Design Excellence Panel Minutes

Application No: DA2021/0152

Property: 2-36 Church Street, Lidcombe

2-36 CHURCH STREET LIDCOMBE
DESIGN EXCELLENCE PANEL PRESENTATION

3.1 SOLAR SHADING PERFORMANCE - 21 DECEMBER

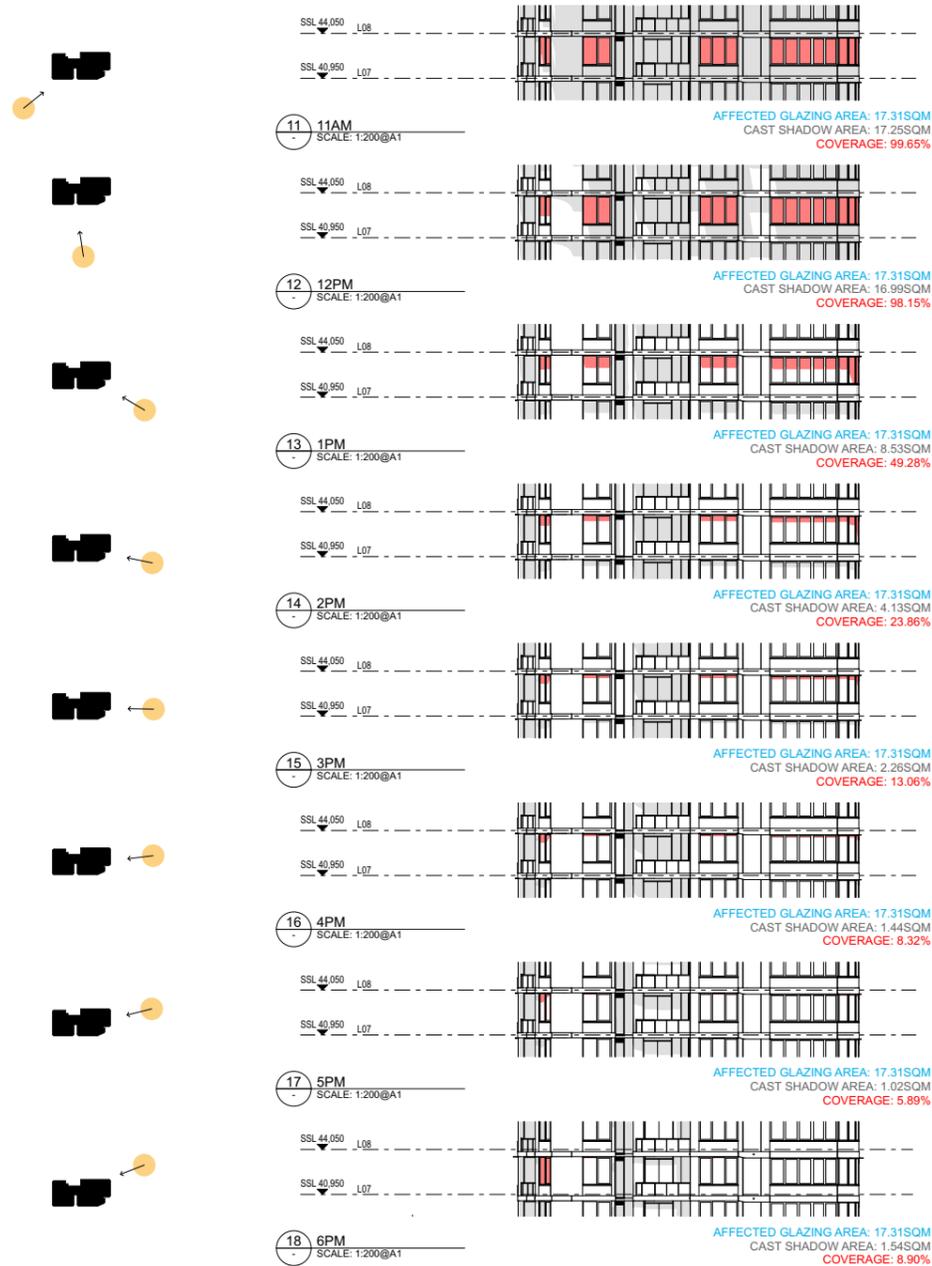
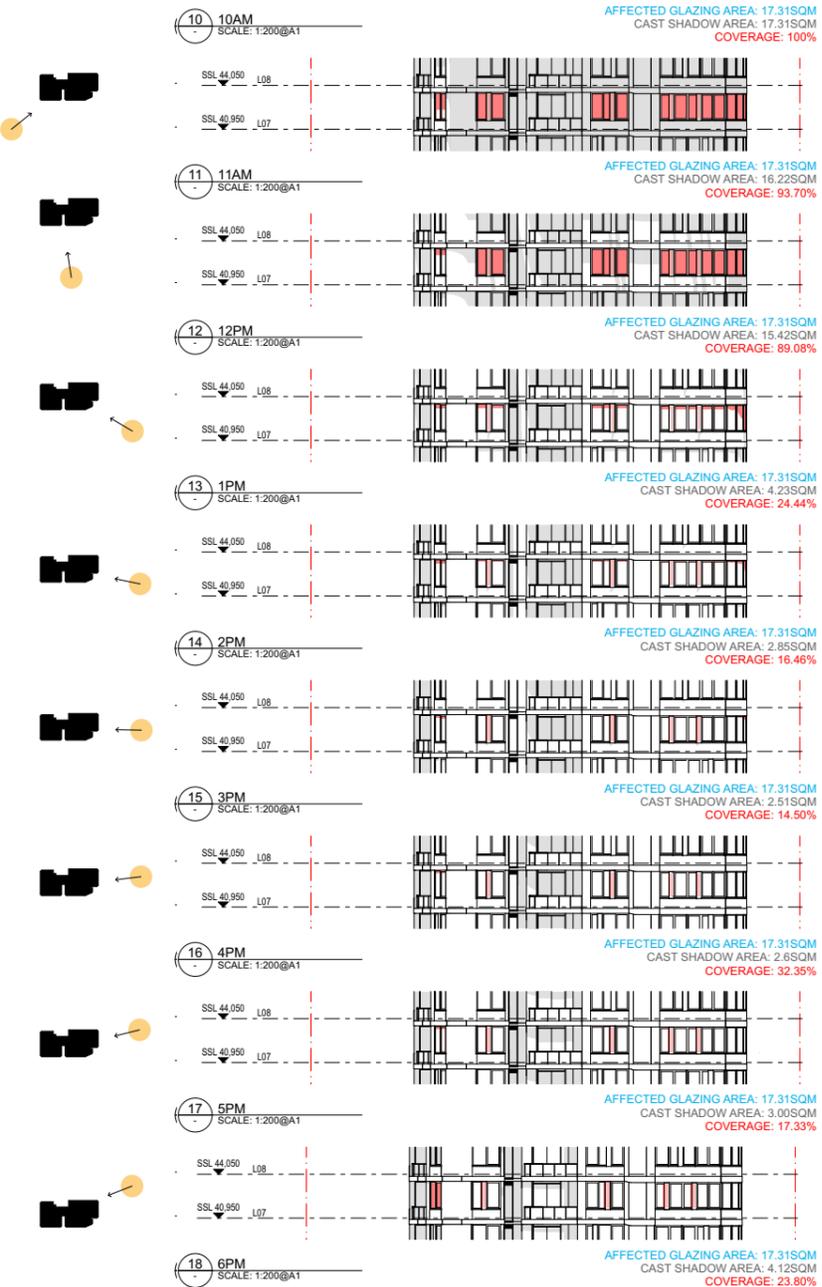
| 3.1 | The Panel acknowledges the addition of sun shading louvres to the north and west faces and suggests that a different approach to the sunshading on the west facing facades e.g. vertical louvres (as originally conceived), may yield better sun protection in low sun angle situations. Revise the strategy to increase the effectiveness of sun control. | Comparison studies between vertical and horizontal with various depth sun shading on northern and western facades. Analysis shows slight improvements in shading between horizontal and vertical with horizontal louvre yielding slightly better results. See analysis below. |

HORIZONTAL LOUVRE 200mm DEPTH

VERTICAL LOUVRE 400mm DEPTH
3-4 LOUVRES ALTERNATING PER FLOOR
TO FLOOR 45 DEGREE ANGLE

5.3 CHILDCARE PRIVACY SCREENINGS

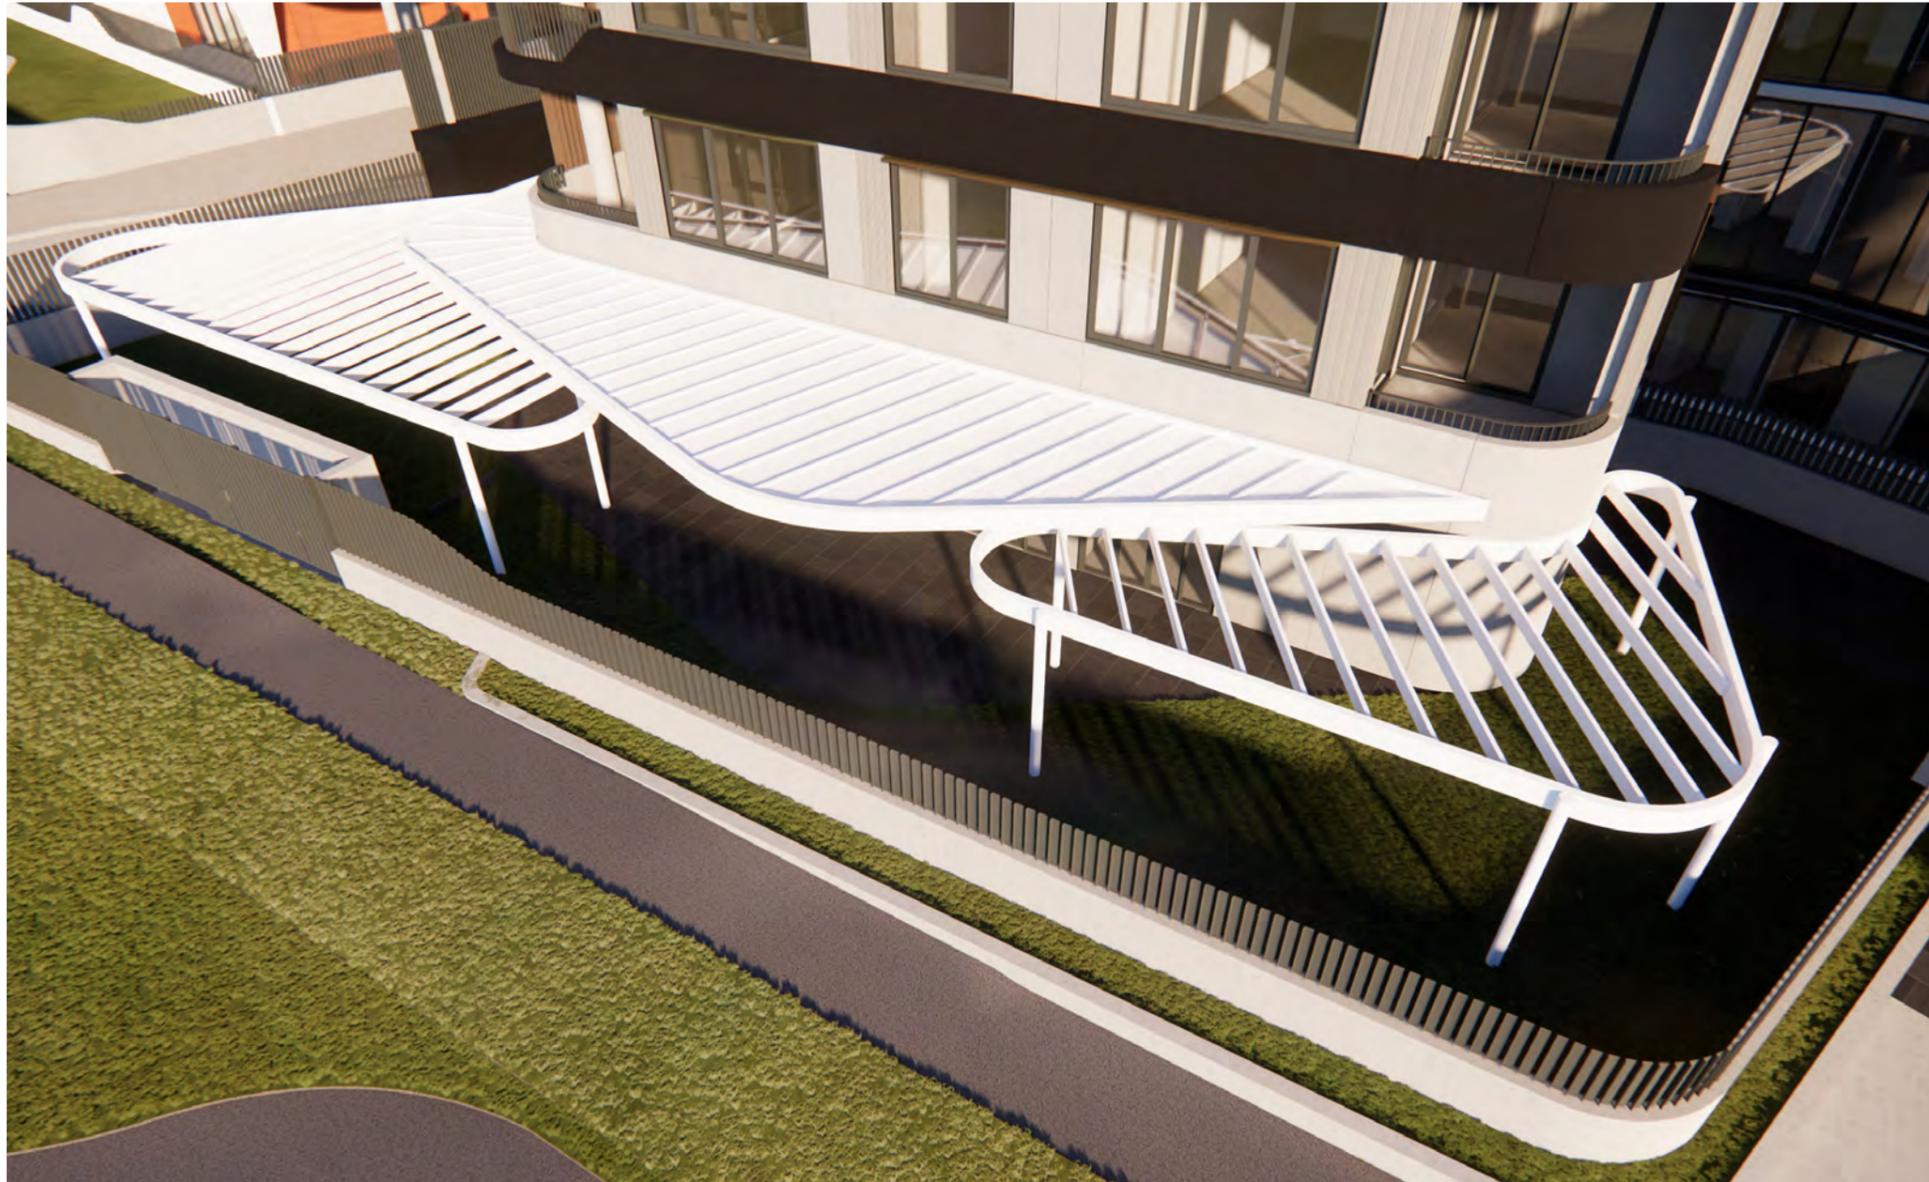
5.3	The addition to the Child Care Centre of external shading canopies and pergolas is a positive contribution to the development. However, reconsider the direction of the pergola louvres to provide increased visual privacy between the playground and the apartments above.	Pergola louvres has been rotated to provide increase visual privacy between playground and apartments above.

PROPOSED DESIGN - HORIZONTAL SUN-SHADING ADDED TO ALL NORTH FACING FACADES. SHADING TO PROJECT 200MM FROM FACADE AND COMPRISE CONTINUOUS METAL PROJECTIONS THAT SPAN ACROSS BOTH GLAZED AND SOLID ELEMENTS OF FACADE, COLOUR MATCHED TO LIGHTWEIGHT CLADDING

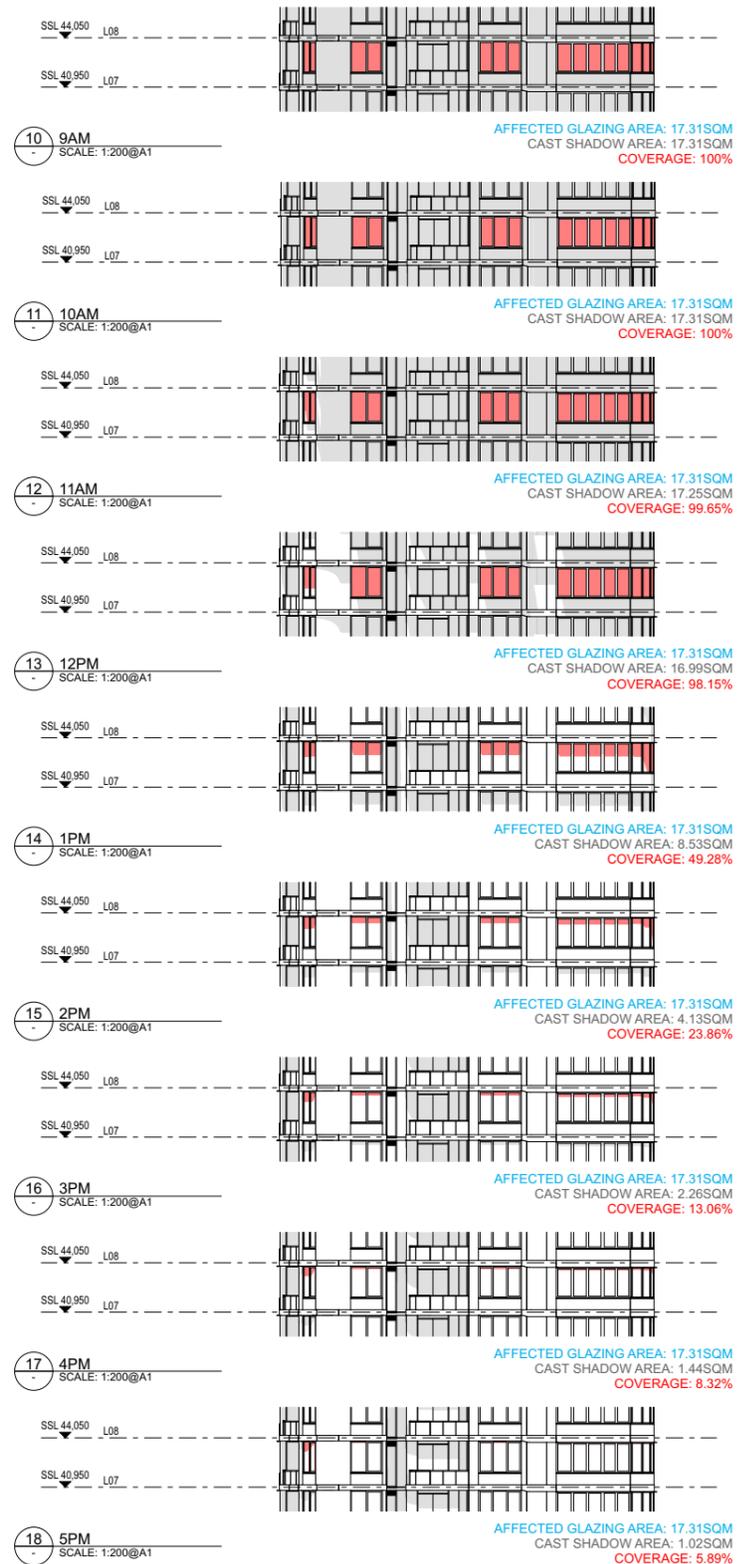
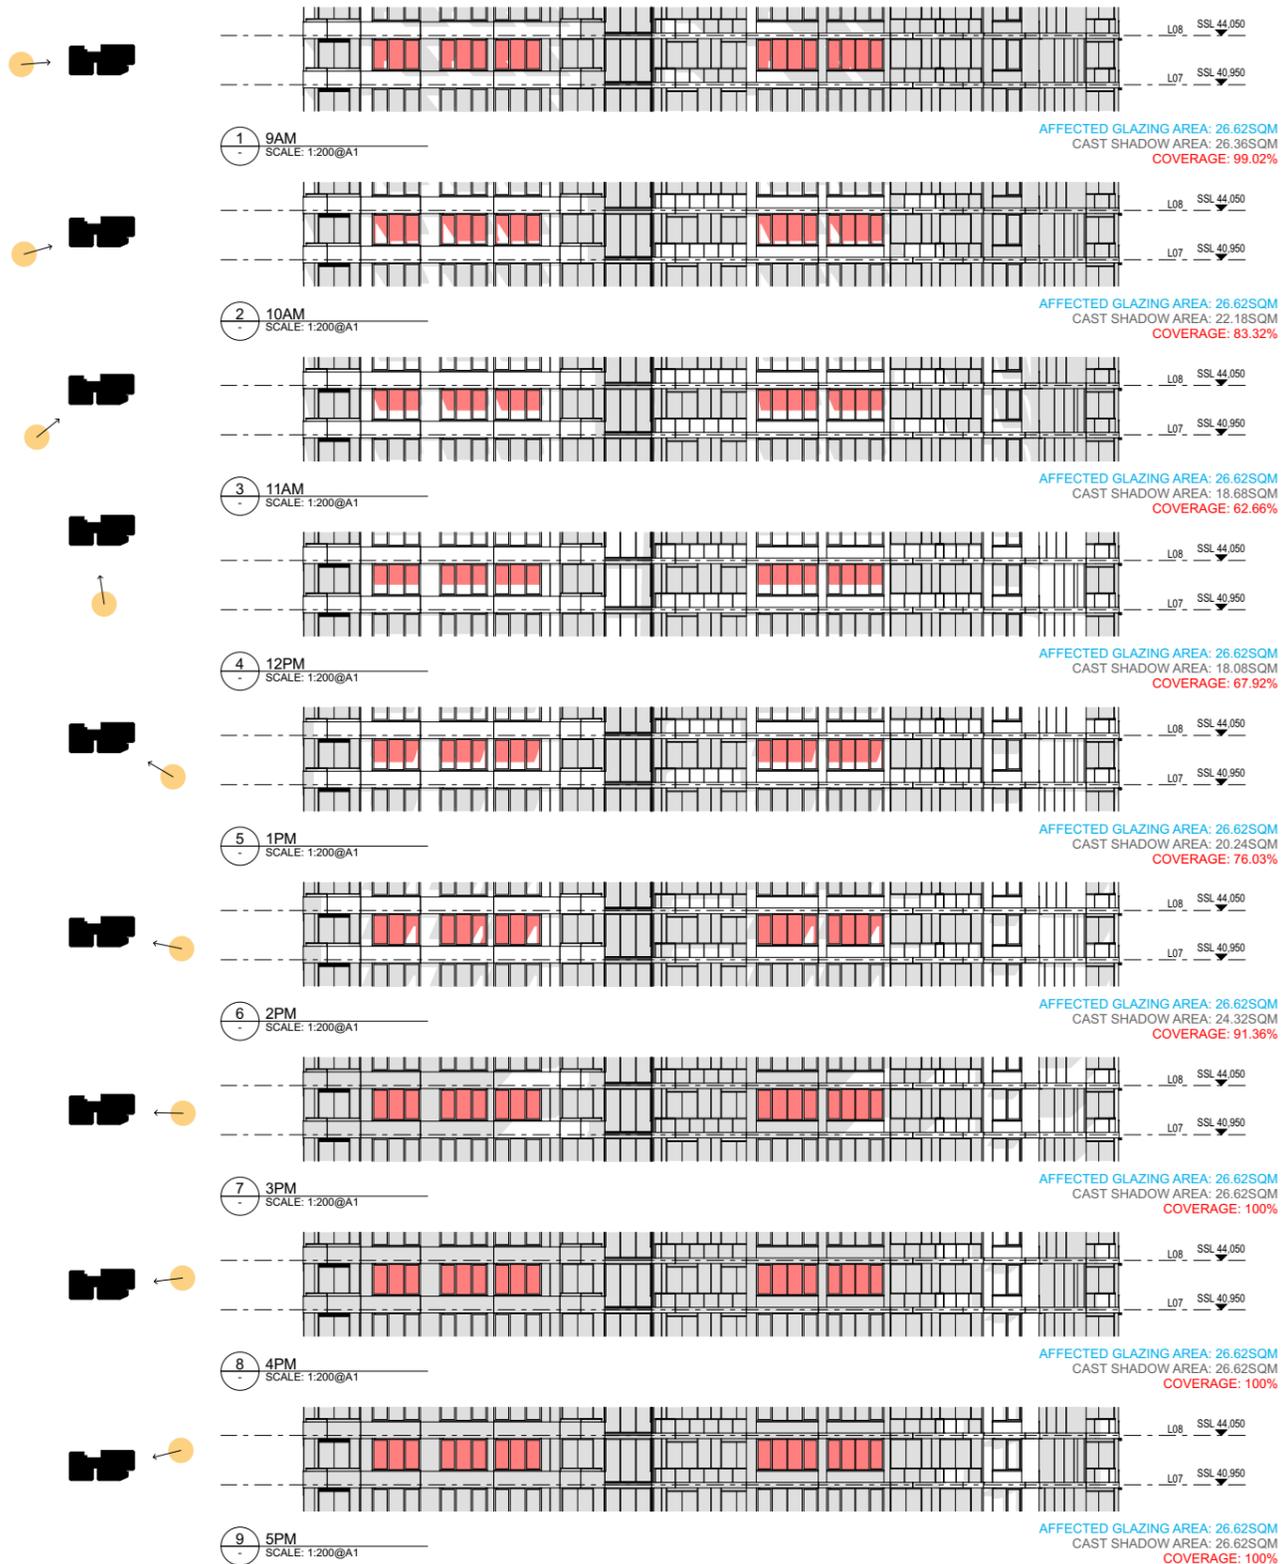
2.1 It was considered that while the architectural expression does have some material and colour variation, a degree of sameness prevails in the language. This issue could be addressed with introduction of a more defined podium base along all 4 buildings that could provide greater variation in finishes, and solar control devices on north and west facing elevations to help reduce heat gain.

The DEP suggestion for horizontal solar control devices for the north and west face has been adopted across all the buildings for instances where there is glazing that is not protected by a balcony overhang. A 200mm deep fin that will provide substantial shading has been introduced in lieu of the vertical fin projections that were part of the original design proposal. The fins are powdercoated to match the aluminium glazing frames.

BUILDING 'C' AND 'D' BUILDING HEIGHT CHANGES

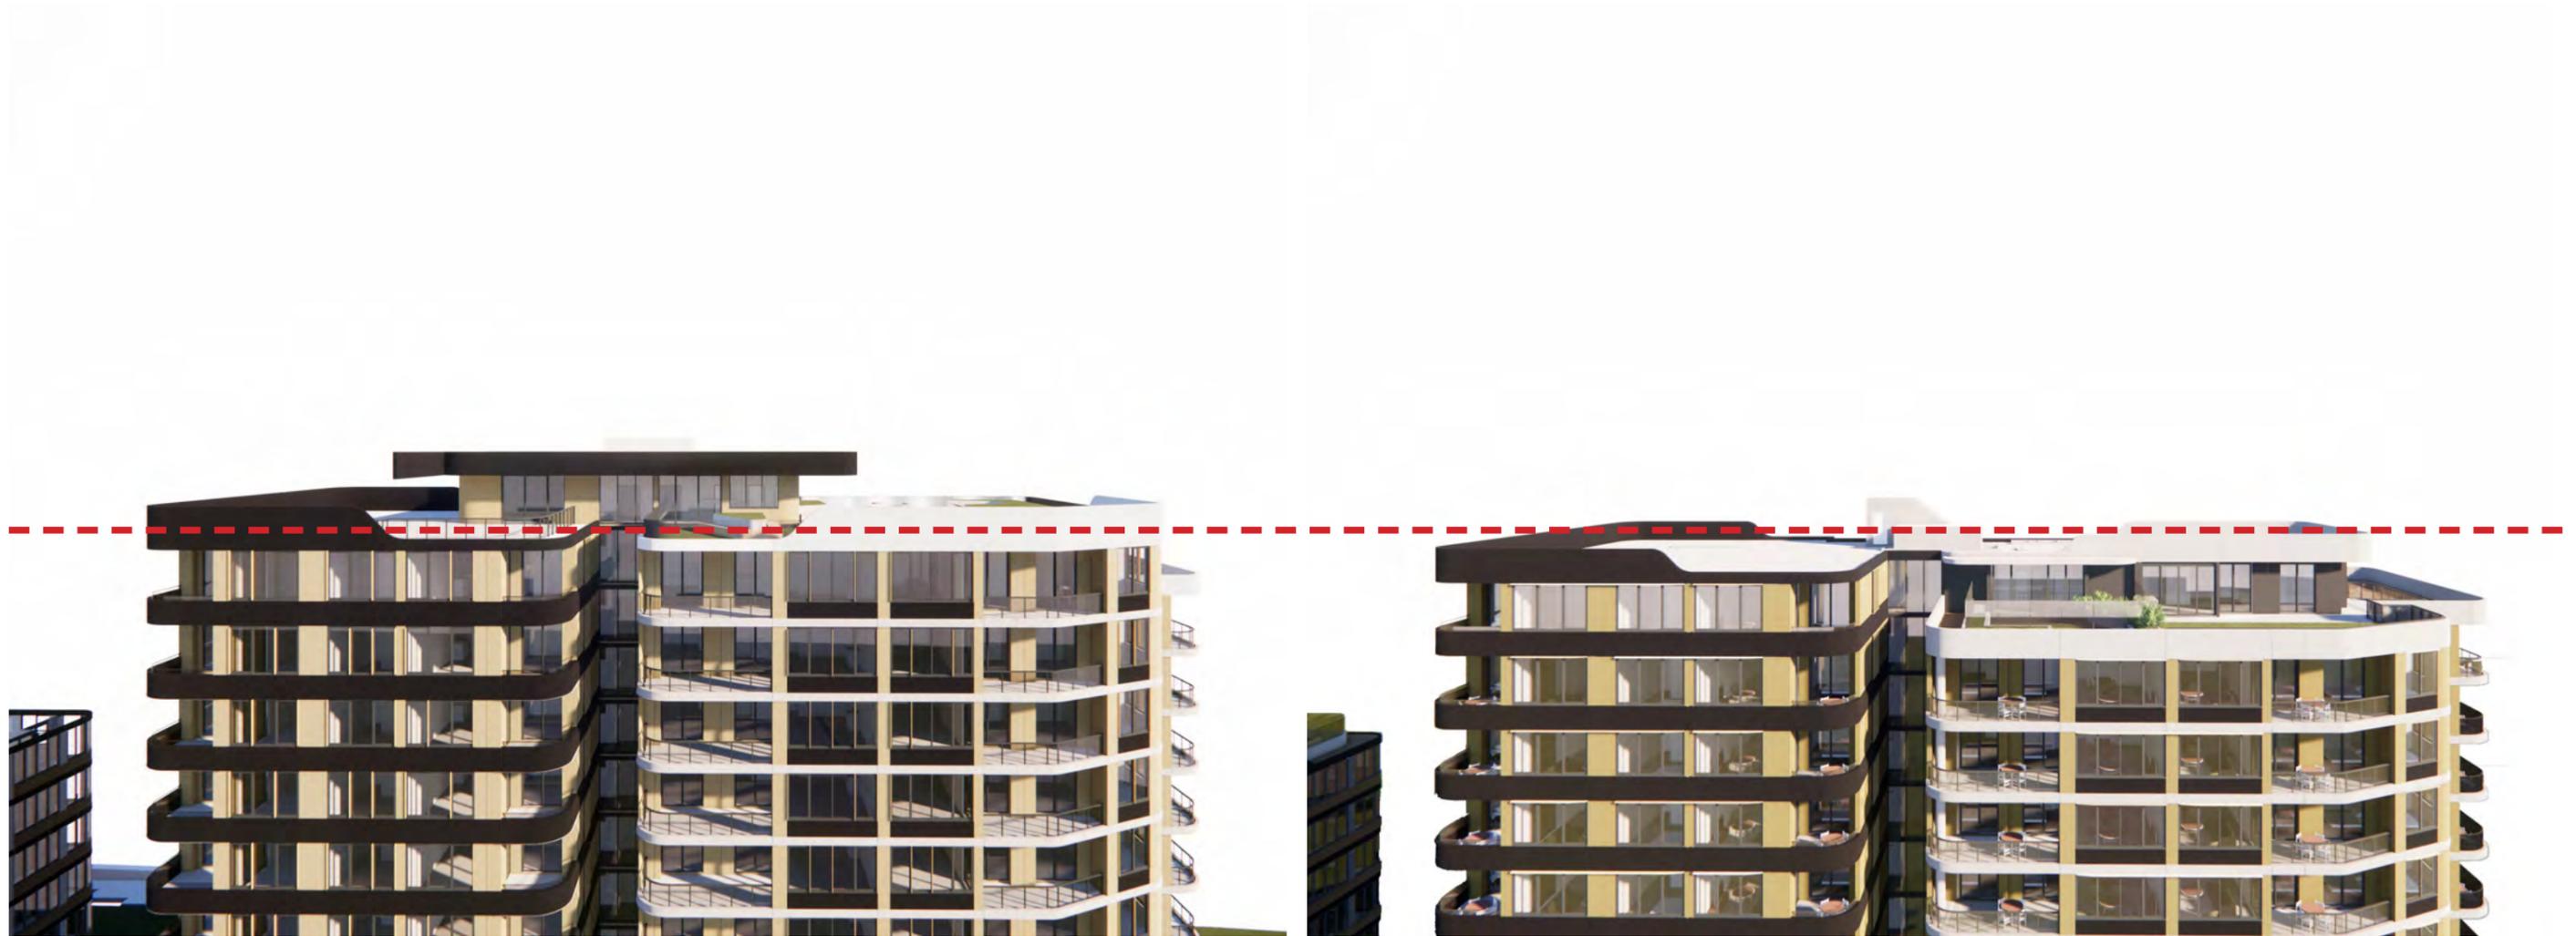
NO	DEP COMMENTS	RESPONSE
	The overall building heights should be reduced to comply with the maximum 40m height limit approved in the Planning Proposal.	The overall heights of Building C and Building D have been reduced so that no part of the development has any habitable or communal area that projects beyond 40m. Further, the footprint of Building D has been amended on the last storey to ensure that habitable spaces are not projecting above the 40m height limit despite the steeply sloping nature of the site at that area. This has further improved the articulation of the development as a whole by providing a stepped building profile that varies across Buildings C and D.
